PLAN 2

PLANNING APPLICATION PLN-20-0075

44 MAIN ROAD, PERTH

Description of proposal: Two lot subdivision of land at 44 Main Road, Perth

PLAN OF SUBDIVISION

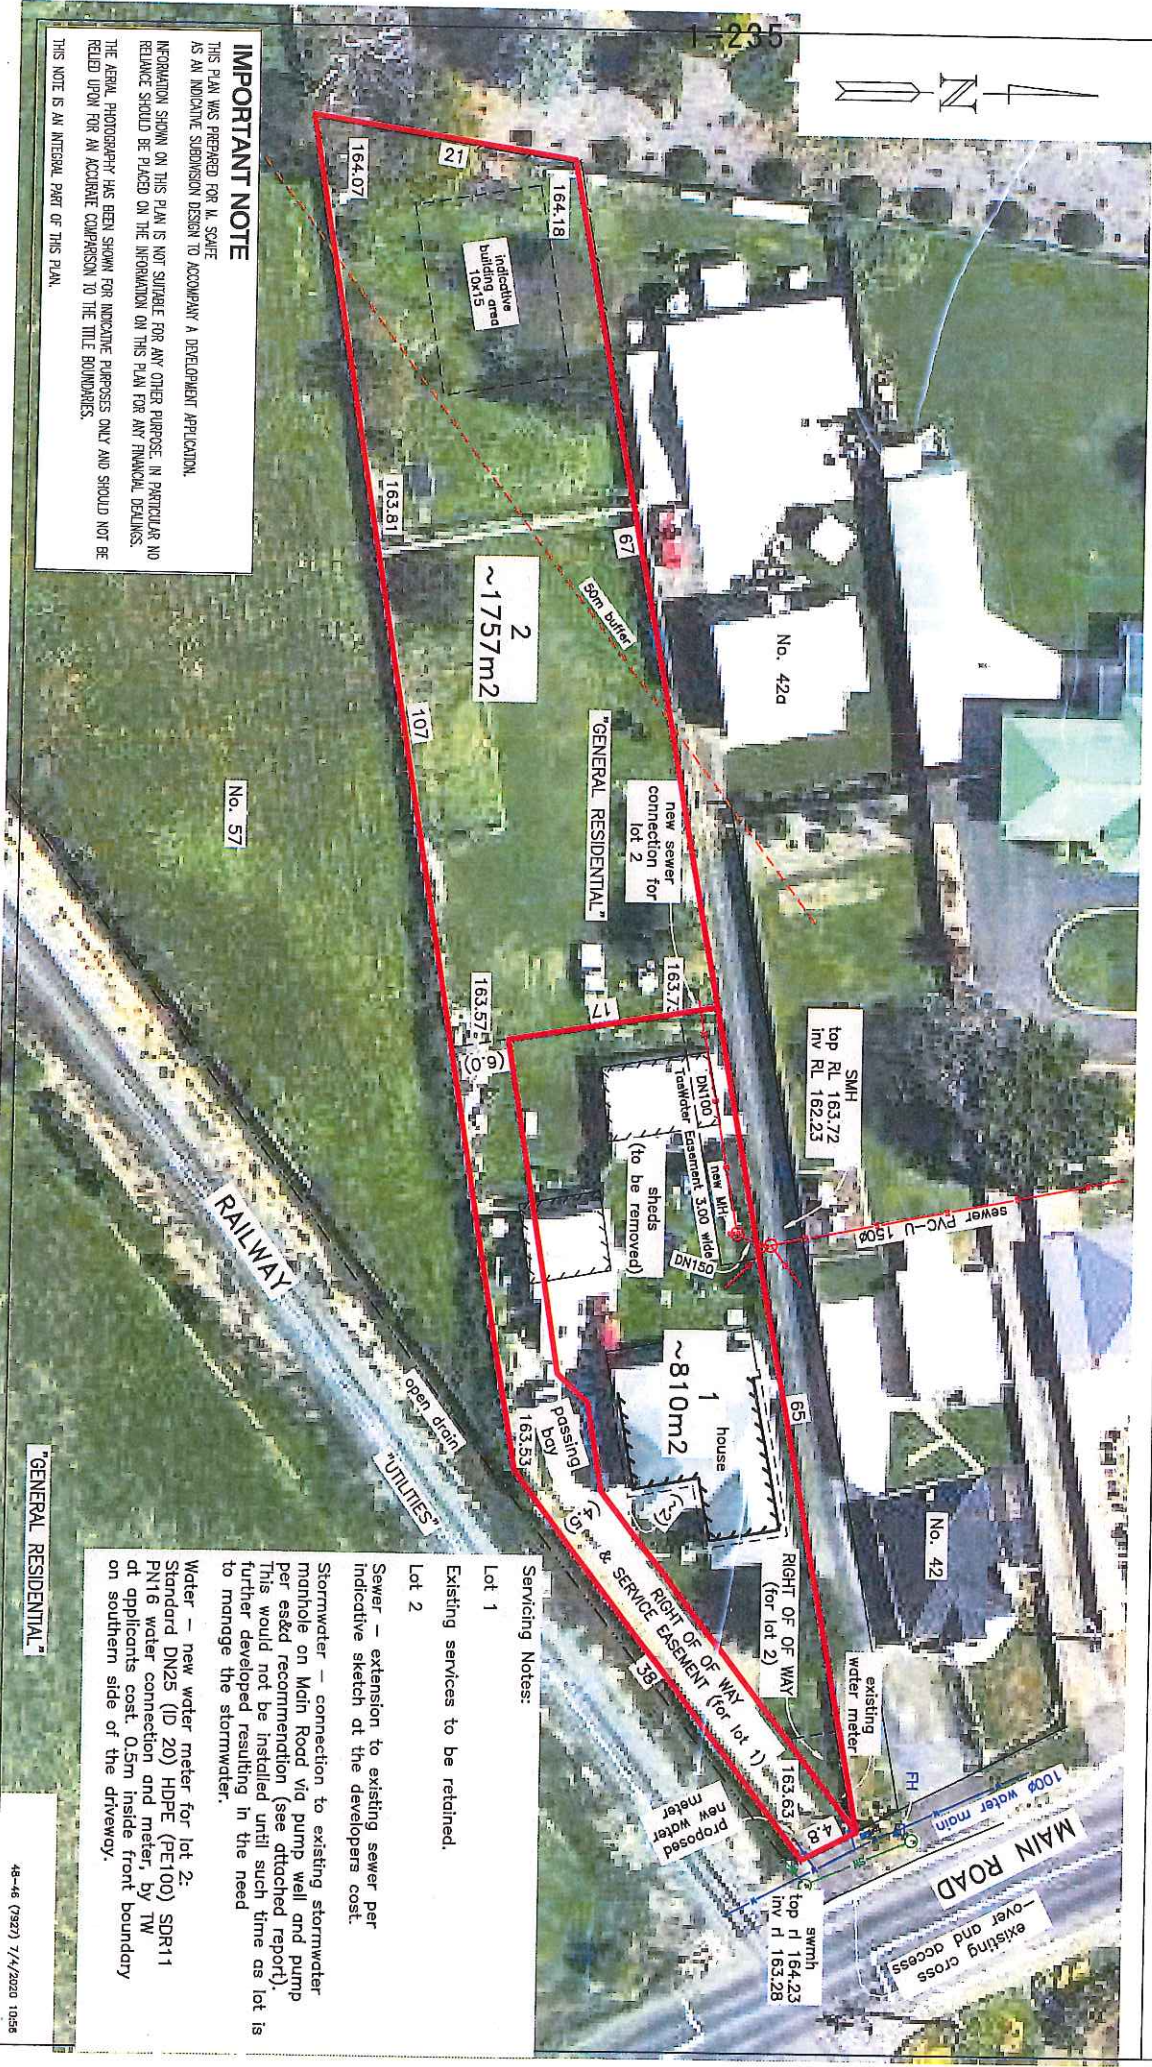
- TasRail notes that the applicants plans show the rail corridor but also show the rail open drain; we also acknowledge that the notes on that plan states that connection to existing stormwater manhole on Main Road would be as per the es&*d recommendation in an attached report. However TasRail could not locate this report to confirm that the stormwater run-off and connection will comply with TasRail's requirements.

- TasRail therefore requests that should Council approve this planning application, the Council Permit conditions make it clear that the stormwater is not permitted to be discharged into the rail corridor or the rail drainage system. It is recommended that the stormwater plan for this property provided to TasRail for review before any works commence, noting that the existing culvert and stormwater outlet appear to be on railway land (see below).

- TasRail notes the submitted plans show an established driveway into Lot 1 by turning from Main Road and across the flow of oncoming traffic into Lot 1 – and this is proposed to become a ROW/access into Lot 2.

PLAN OF SUBDIVISION

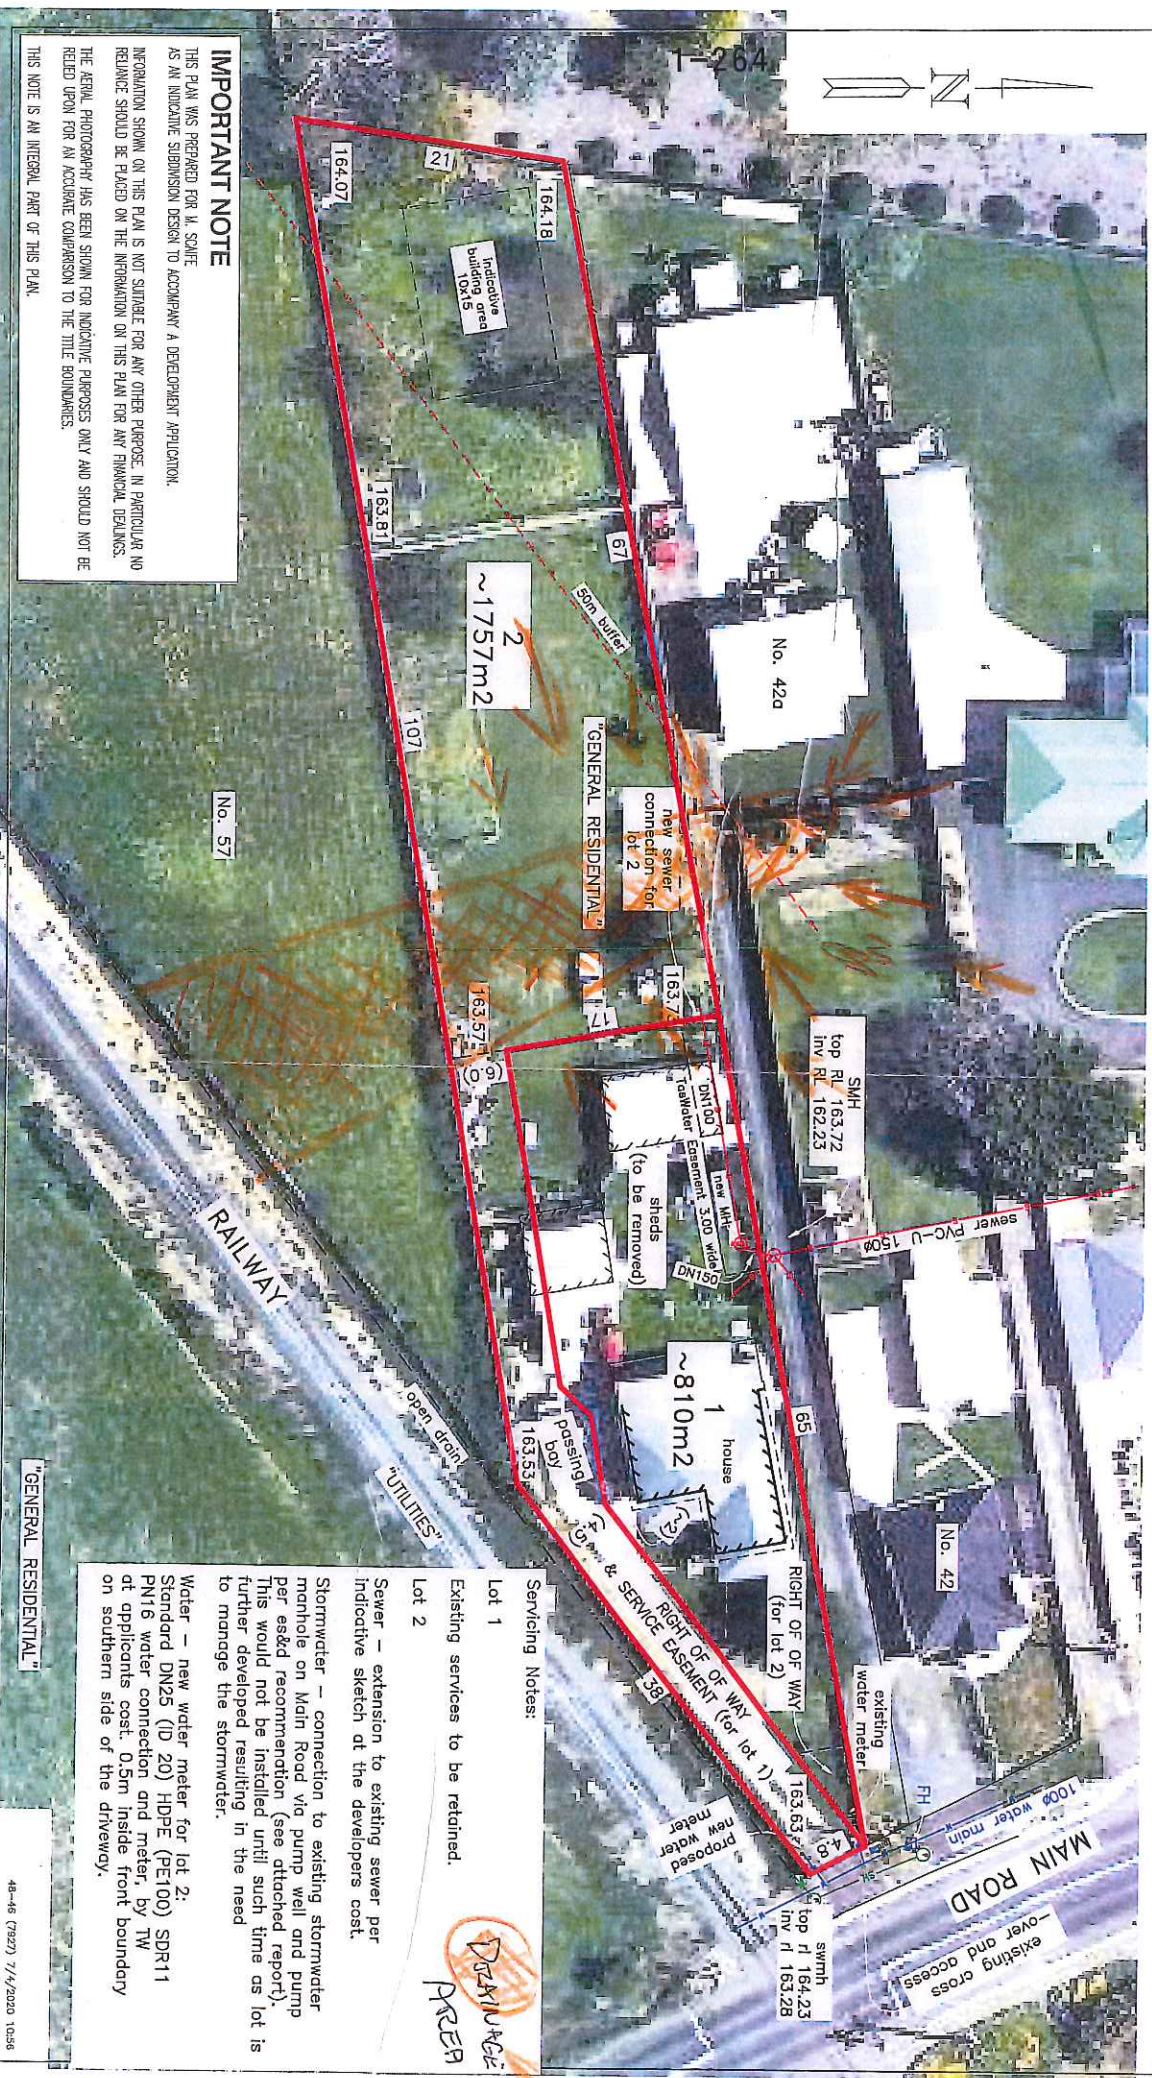
I HAVE NO OBJECTION TO RESIDENCE BEING BUILT AS SHOWN
 ON PLAN OF SUBDIVISION REF 48-46(7927)

DURING WETTER MONTHS DUE TO THE NATURAL ELEVATION OF
 SURROUNDING PROPERTIES INCLUDING 42 42^A 40 40^A
 WHICH RUNS ACROSS 44 & 57 TOWARDS OPEN DRAIN ON RAILWAY
 LINE LAND (SEE DIAGRAM MARKED IN ORANGE ON SUBDIVISION PLAN)
 DURING WET MONTHS WATER CAN BE UP TO 100^{mm} IN DEPTH
 APPROXIMATELY 42^A & LOT 2 44.

IF THE PROPOSAL GOES AHEAD WHAT PLANS WILL BE PUT INTO PLACE DURING CONNECTION ALLOWING ME TO ACCESS MY RESIDENCE
